Subject: Requested Shoreline Evaluation

To: Deb Beutel, Corrotoman by the Bay Association (HOA)
PO Box 99, Mollusk, VA 22517, Lancaster County

From: Northern Neck Master Gardeners – Shoreline Evaluation Program (SEP)
Volunteers: Carol Martin, Susan Lindsey, Gail Cooper and Ian Cheyne

Date: November 25, 2019

SECTION A-A
 FOR
ROYER & HAMER RESIDENCES:
SHORELINE IMPROVEMENTS
 LOCATED AT
1718 CORROTOMAN DR.
 WHITE CHAPEL DISTRICT
 LANCASTER COUNTY, VIRGINIA
 AUGUST 8, 2019
 SHEET D4 OF D6

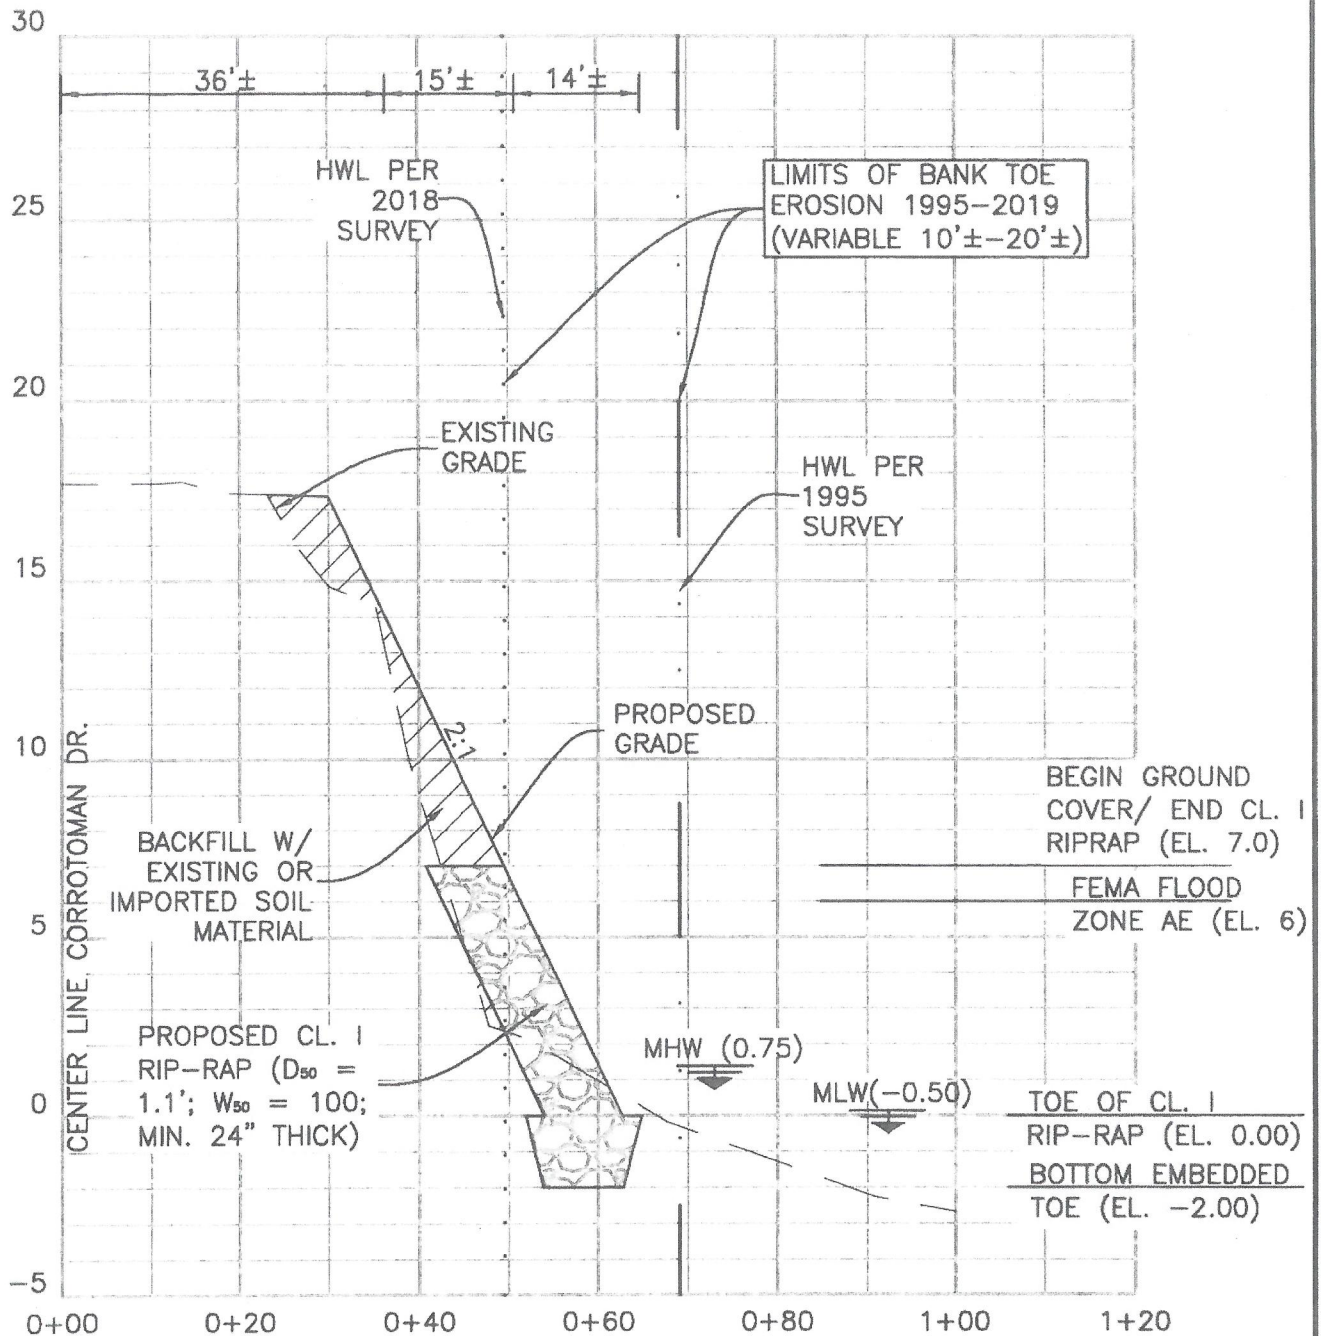
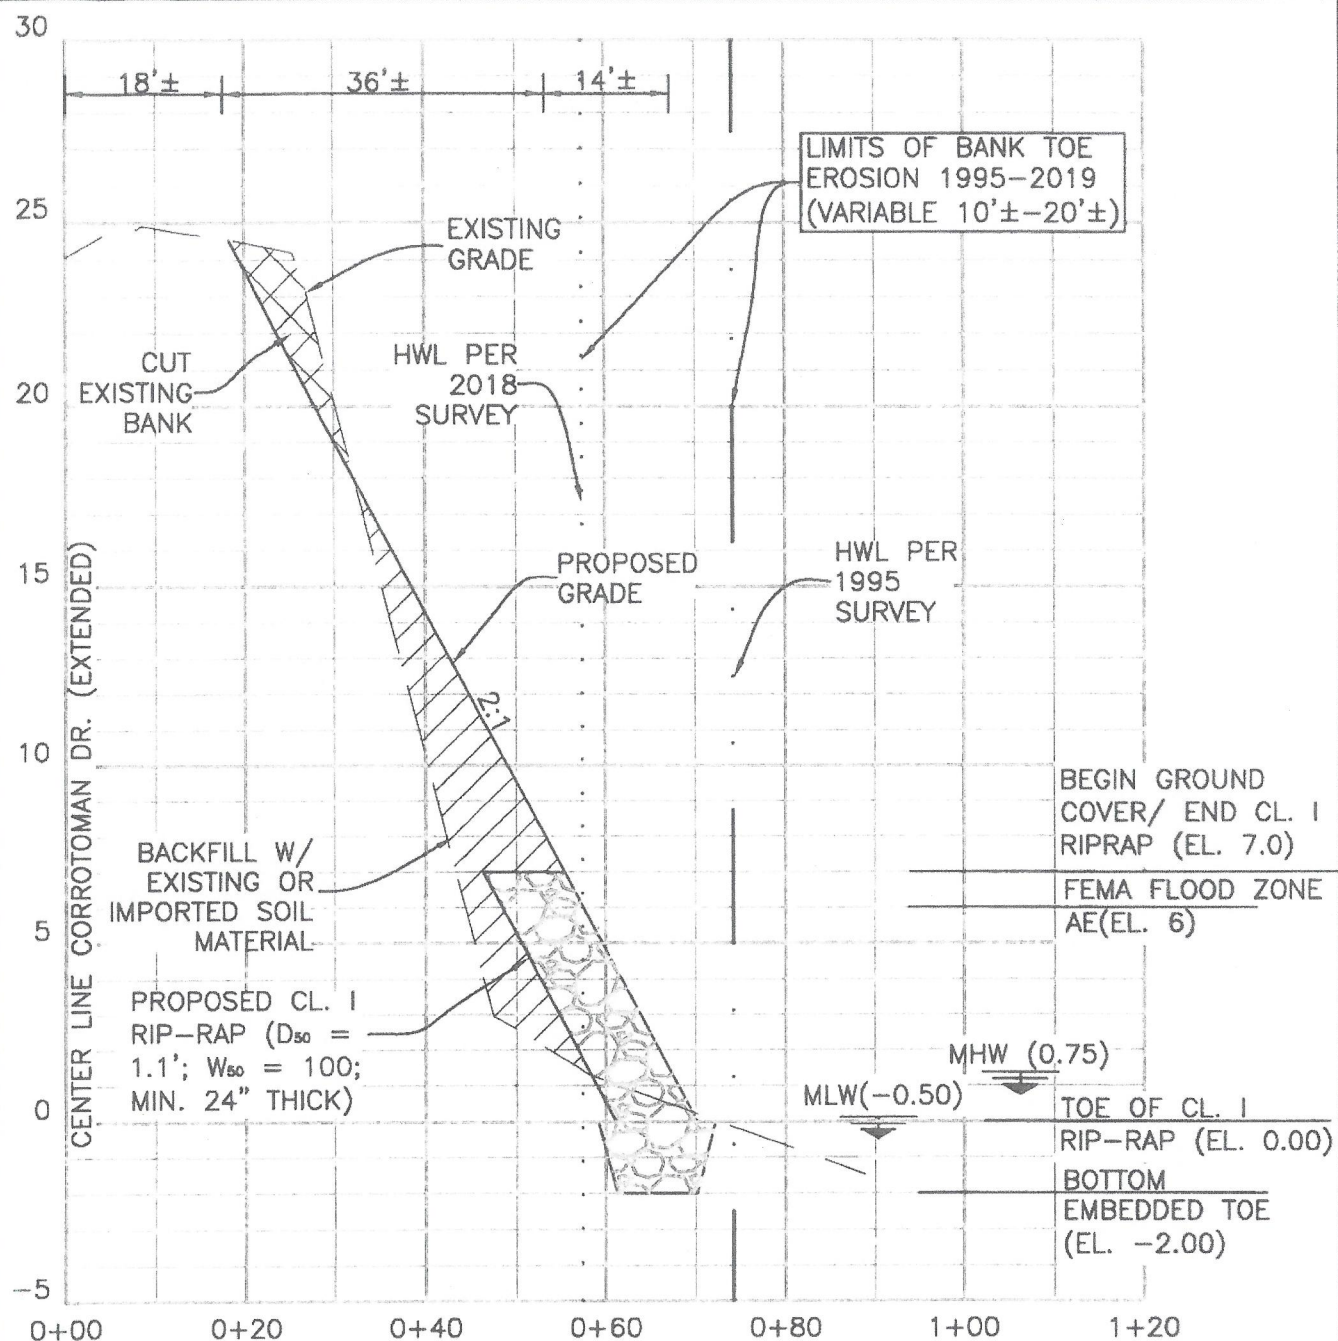
- a. The revetment is designed to protect the foot of the bank and at 7ft high may offer longer term protection against sea-level rise than the constructed marsh.

- d. The upper 1:2 slope may present challenges to stabilize and vegetate the bank, particularly given the sand substrate once the protective layer is removed.

- e. Maintenance of the slope may be challenging given its steepness and that the base of the revetment will be under water most of the time.
- f. All trees plus other vegetation will be removed from the slope exposing the top of the slope to northerly winds.

LIVING SHORELINE WITH ROCK SILL ILLUSTRATION OF SITE VARIABLES

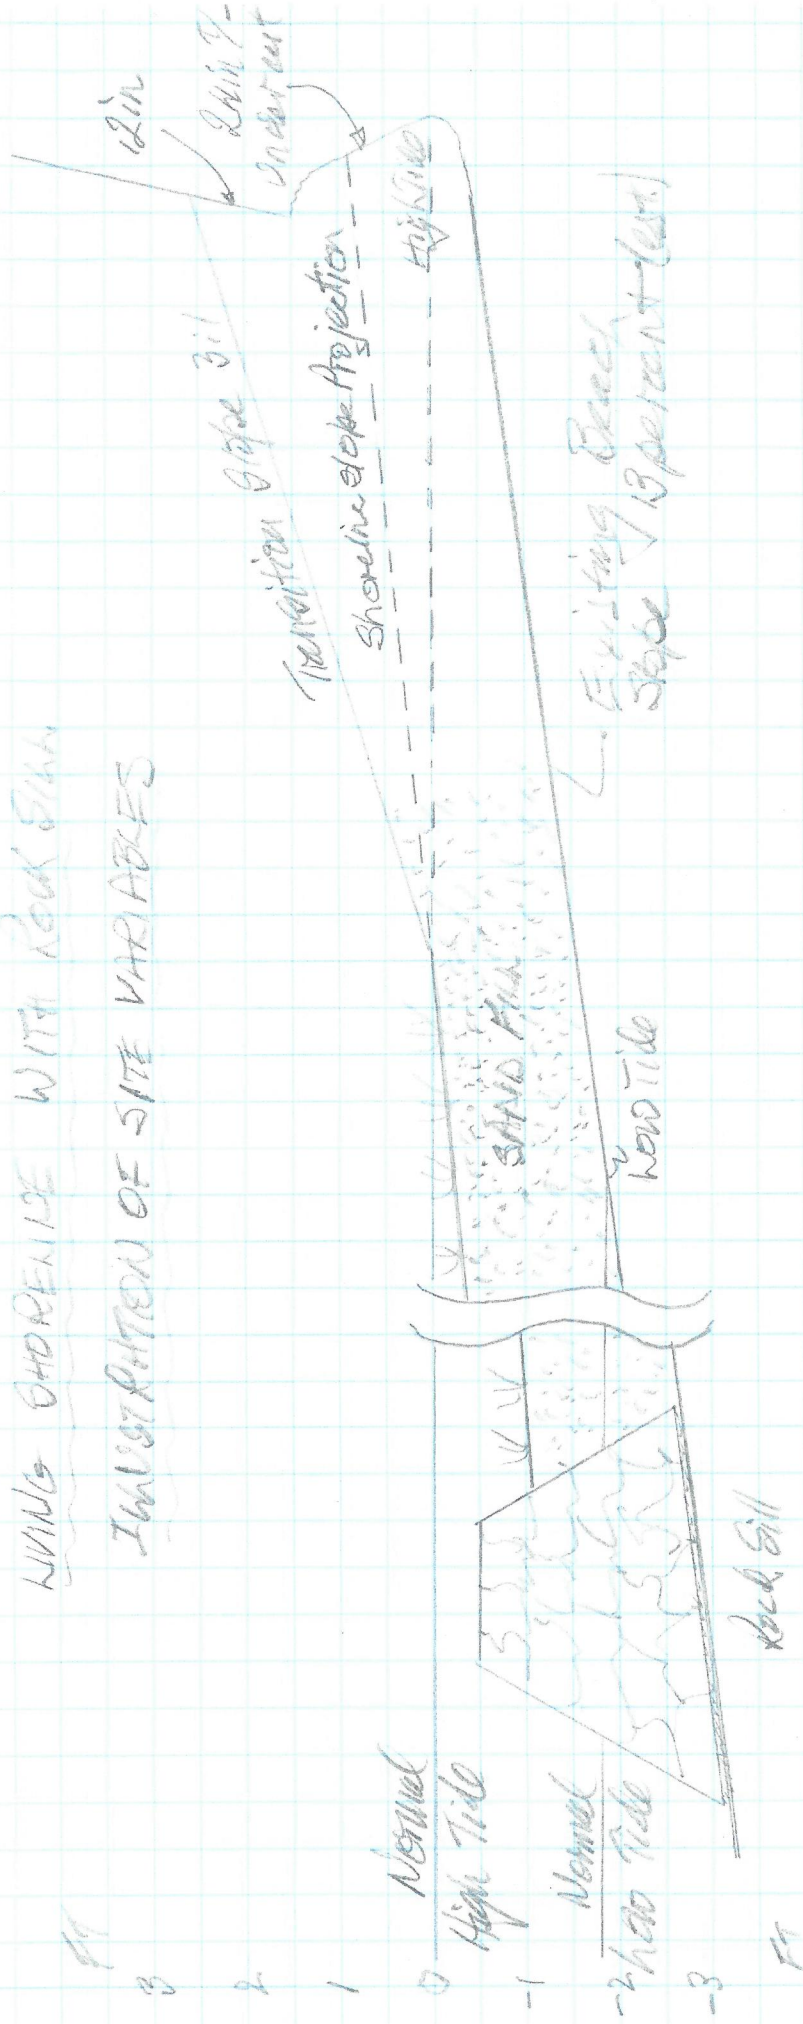
- a. The recommended marsh slope for a living shoreline is 1:10. (Ref.2)
- b. To provide long term protection the marsh slope should meet the existing shoreline significantly above the tidal undercutting such that a normal high tide will not reach the existing bank.
- c. Because the bank is steep and undercut in places, this situation will probably require a transitional living shoreline. That means a section of steeper slope will be constructed between the marsh and shoreline bank joining the bank above normal high tide. This section will integrate into the existing bank and be planted with high marsh vegetation. See sketch (Attach 5).
- d. The supporting sill should be below water at high tide
- e. Normal high tide should flood enough of the reconstructed beach slope to support a grass marsh. A marsh a minimum of 15ft wide is recommended.
